Agenda Item 1 June 22, 2015

**SUBJECT:** Consideration of the request of Beck South, LLC for JSP13-75 with Zoning Map Amendment 18.706 to rezone property in Section 29, on the southwest corner of Beck Road and Ten Mile Road from R-1, One-Family Residential to R-3, One-Family Residential with a Planned Rezoning Overlay. The property totals 41.31 acres and the applicant is proposing a 66-unit single-family residential development.

# **Planning Review**

Rezoning request from R-1, One-Family Residential to R-3, One-Family Residential with Planned Rezoning Overlay (PRO) – Revised Concept Plan

144 Joh 18-064 APPROX. INVERT ELEVATIONS PLAN (8) SEEDER, KASSTERKE, LC.) W FIGURE

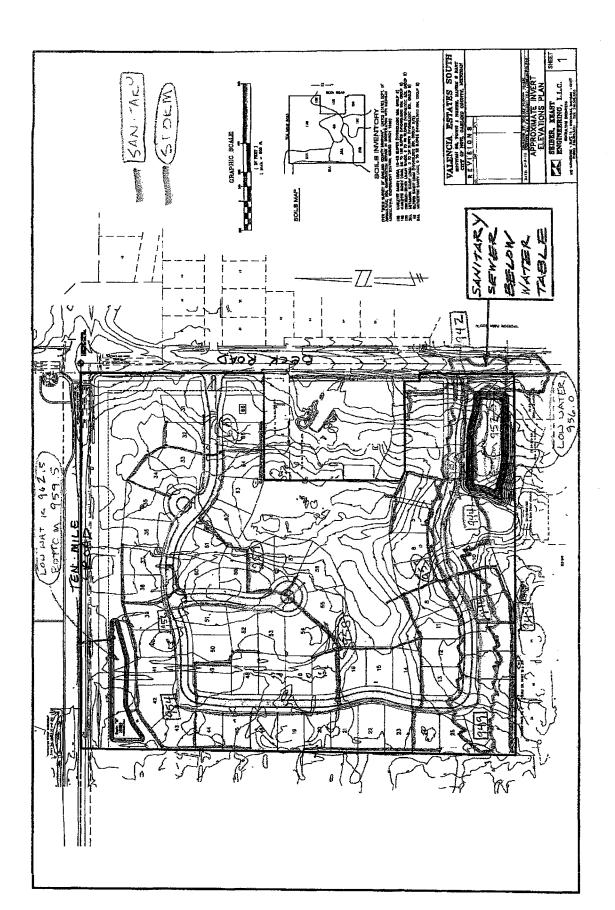
However, it appears that the sanitary sewer inverts along Lots 26 through 30, 9, 10, and the south boulevard entrance off of Beck Road and the required sanitary sewer stub along Beck Road would be at Elevations 942' to Elevation 949'. Those invert elevations are below the water table and may require dewatering for their successful installation. This area is indicated on Figure 3 and is discussed further later in this report.

From the preceding sections of this report, it may be seen that only a small portion of the site will need dewatering and this is for the proposed sanitary sewer in the south of the site (see Figure 3). Further, it is anticipated that groundwater levels will become lower than indicated by the soil borings during the summer months since groundwater levels usually fluctuate seasonally with their lowest levels happening in the drier summer months. Therefore, some of the indicated dewatering area, particularly at the southwest corner of the site may not be necessary.

**Figure 1**. City of Novi Regulated Wetland & Woodland Map (approximate property boundary shown in red). Regulated Woodland areas are shown in green and regulated Wetland areas are shown in blue).

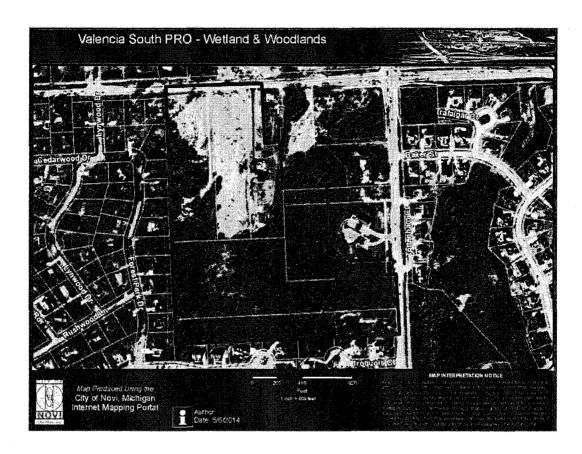
The entire site is approximately 41 acres with regulated woodland mapped across a significant portion of the property, generally located within the southern half (see Figure 1). A portion of the northern section of the site contains disturbed/cleared land associated with the parcels located along Ten Mile Road. The highest quality woodlands on site are found in the central and southern sections of the site. Some of these areas also contain regulated wetlands. It appears as if the proposed site development will involve a significant amount of impact to regulated woodlands and will include a significant number of tree removals.

FIGURE 3 - APPROX. INVERT ELEVATIONS PLAN (BY SEIBER, KEAST ENG'S, LLC)

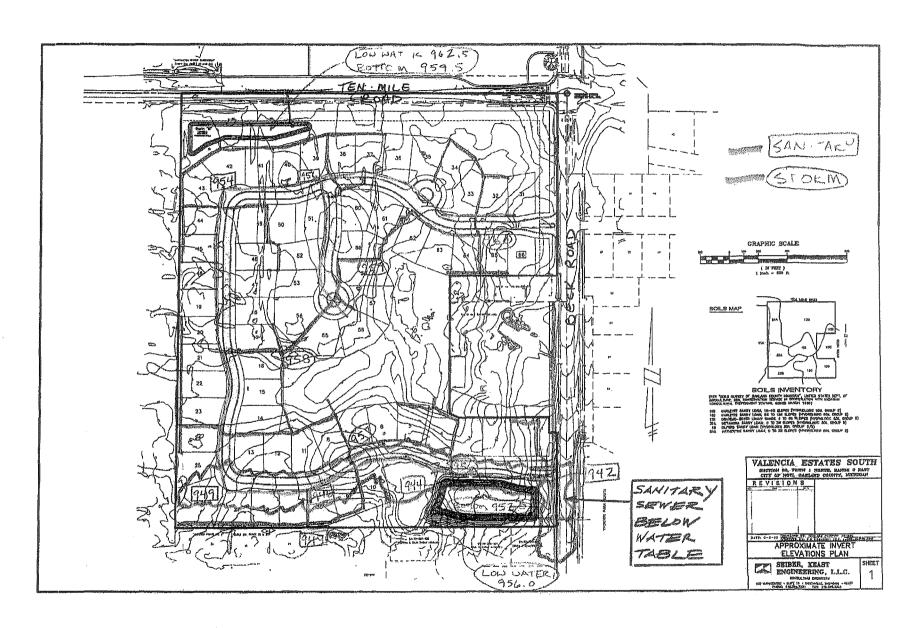
However, it appears that the sanitary sewer inverts along Lots 26 through 30, 9, 10, and the south boulevard entrance off of Beck Road and the required sanitary sewer stub along Beck Road would be at Elevations 942' to Elevation 949'. Those invert elevations are below the water table and may require dewatering for their successful installation. This area is indicated on Figure 3 and is discussed further later in this report.

From the preceding sections of this report, it may be seen that only a small portion of the site will need dewatering and this is for the proposed sanitary sewer in the south of the site (see Figure 3). Further, it is anticipated that groundwater levels will become lower than indicated by the soil borings during the summer months since groundwater levels usually fluctuate seasonally with their lowest levels happening in the drier summer months. Therefore, some of the indicated dewatering area, particularly at the southwest corner of the site may not be necessary.
